SUBJ: **Addendum 1 – Clarifications to the Specifications and Responses to Vendor's Questions**

BID ITEM: **Bid Item #23-150 Construction - Airfield Electrical System Upgrade for Runways 5-23 & 11-29 for Augusta, GA – Daniel Field Airport**

ADDENDUM NO. 1

E11
Sheet 35 of 52

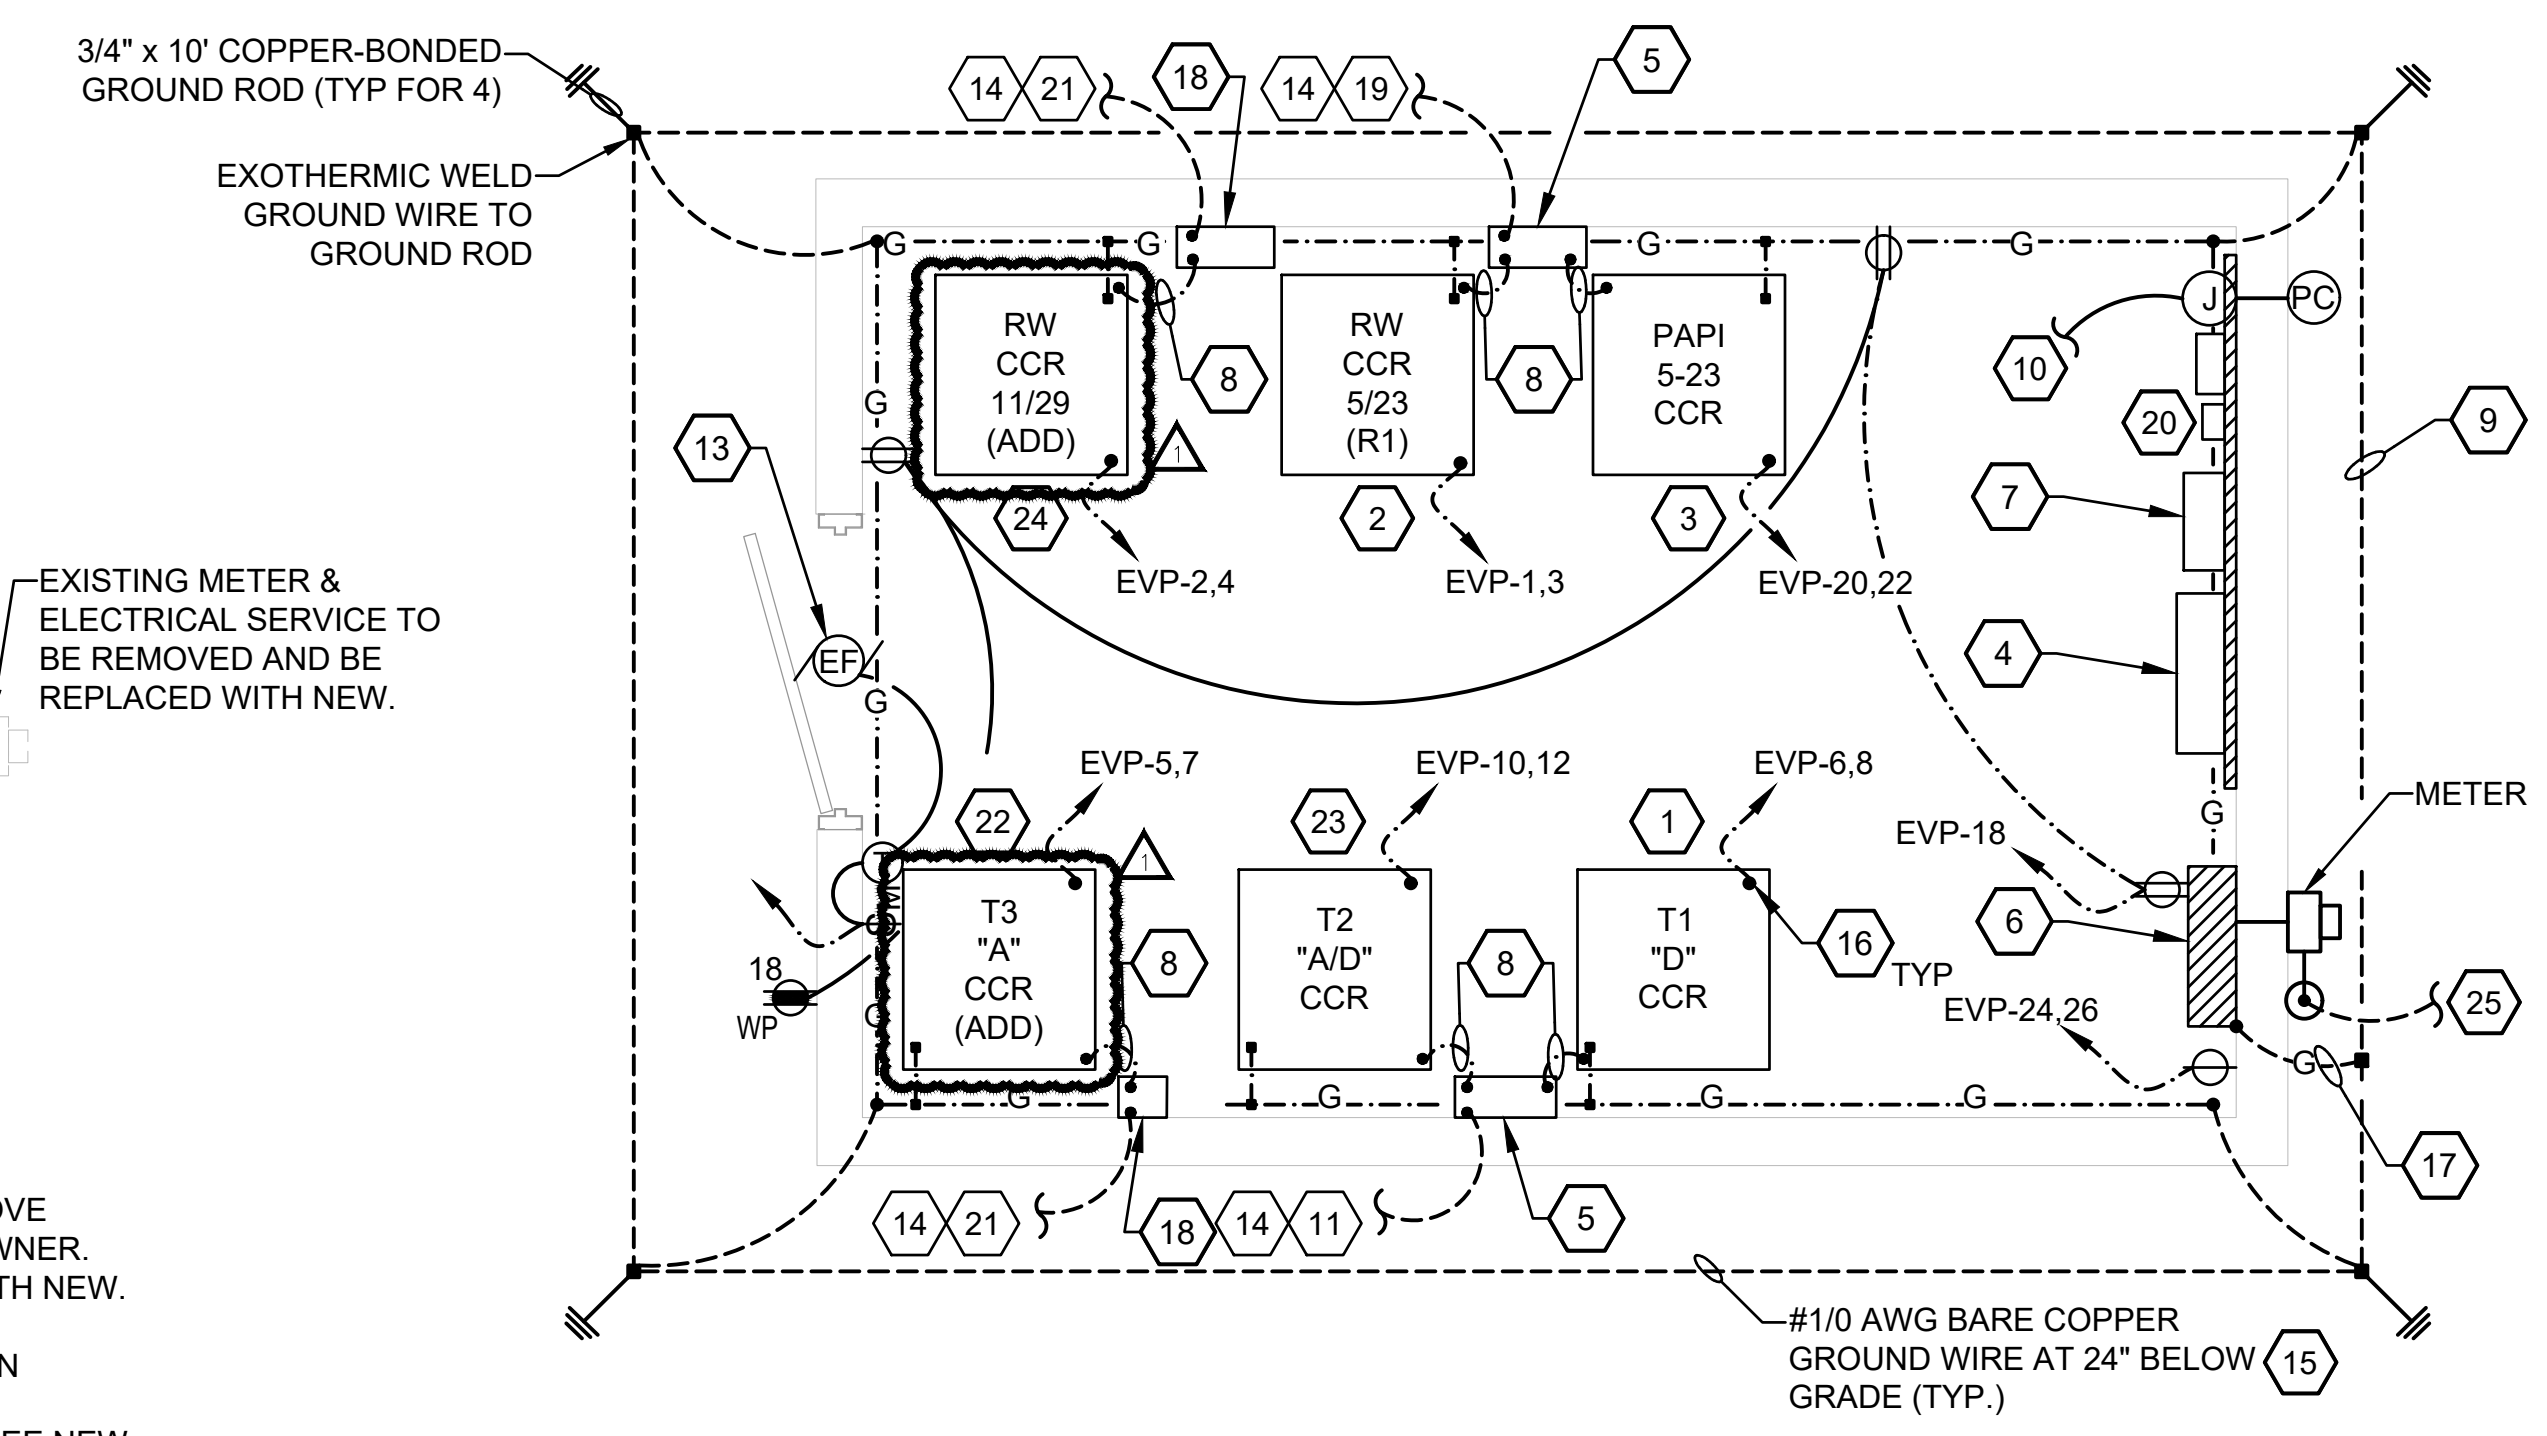
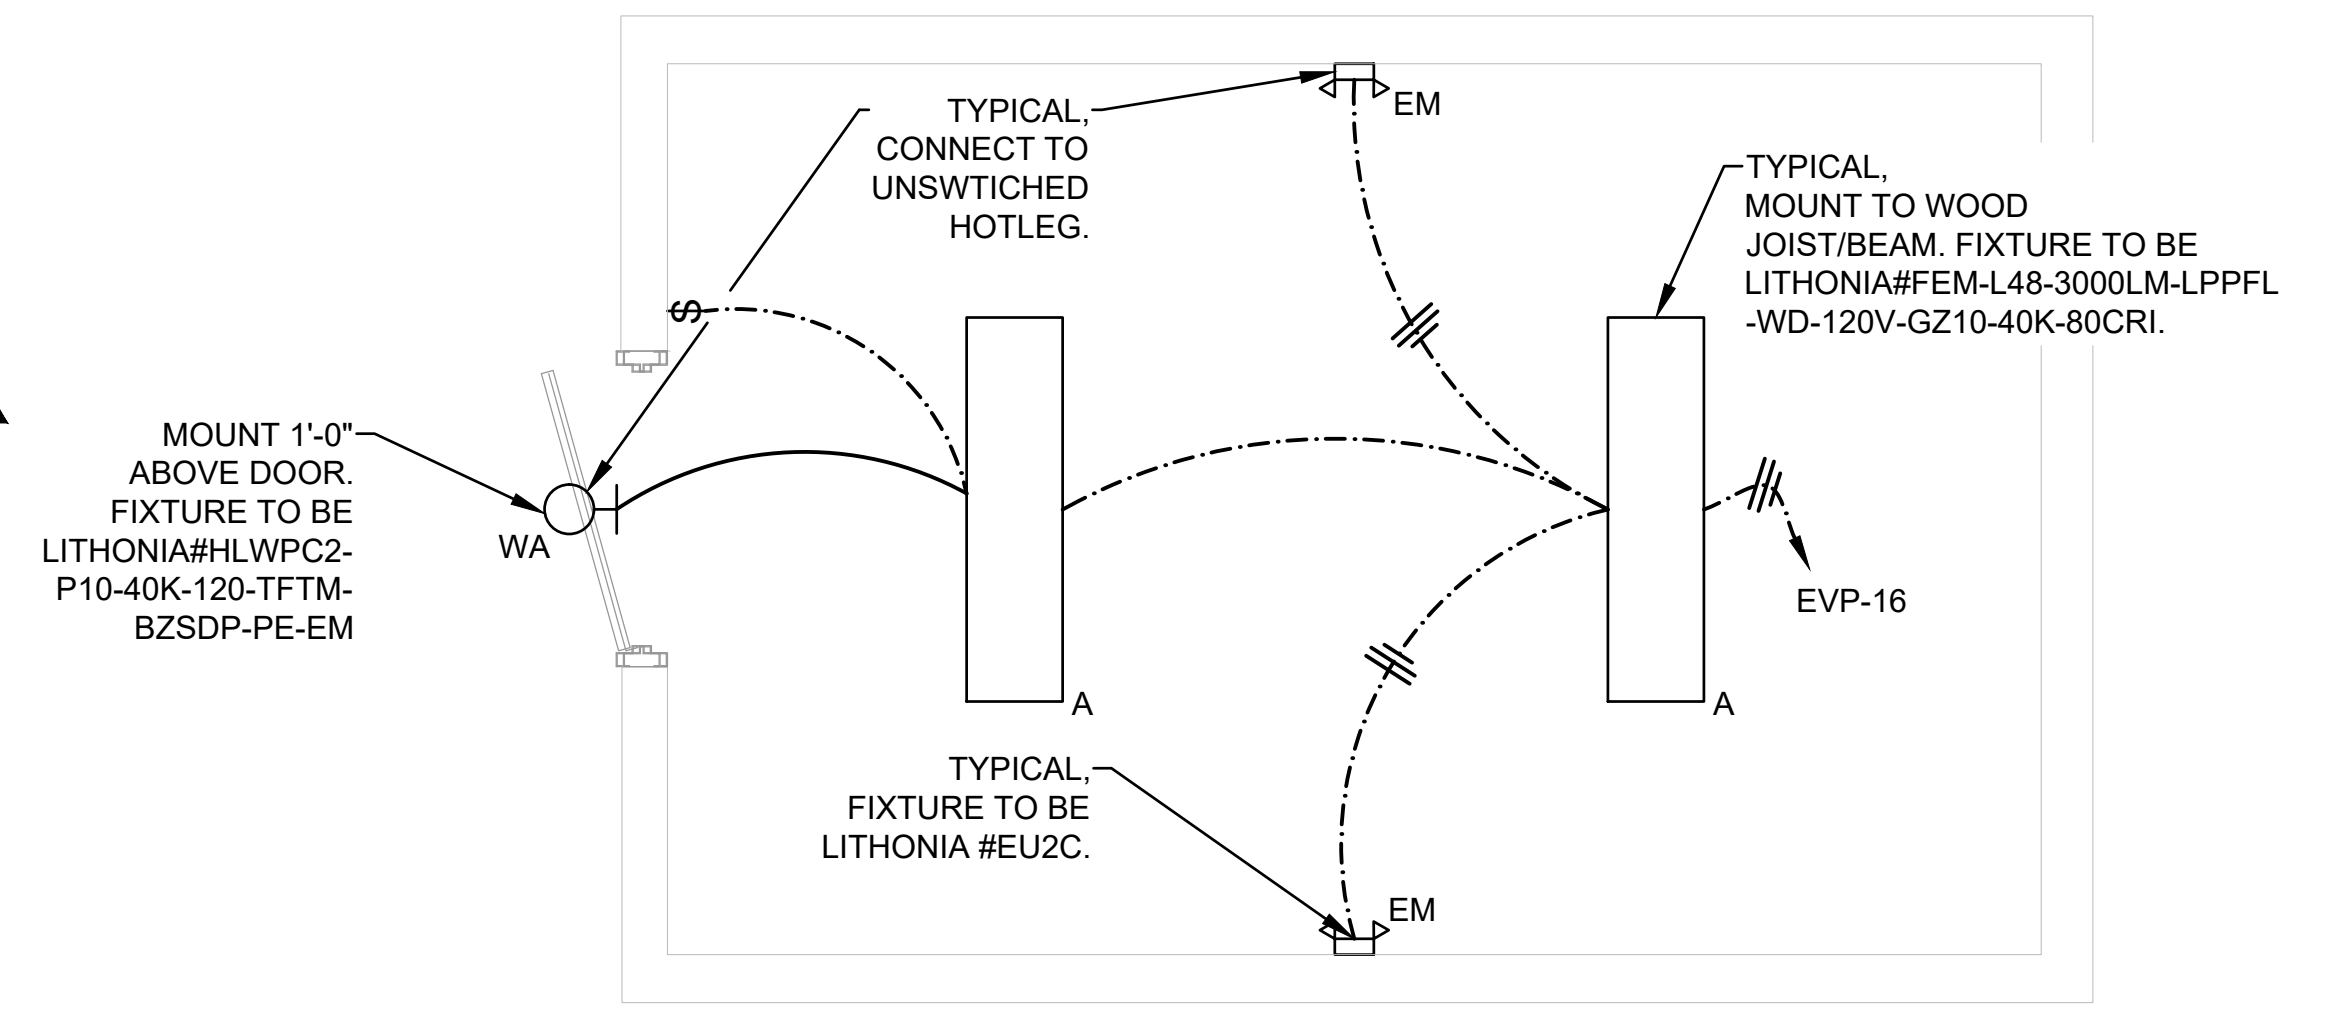
- ALT (Alternate) abbreviation and wording revised to ADD (Additive Bid).
- V. **Replace Sheet E12** – Electrical Power & Control Diagrams with revised Sheet E12 attached to this Addendum 1.
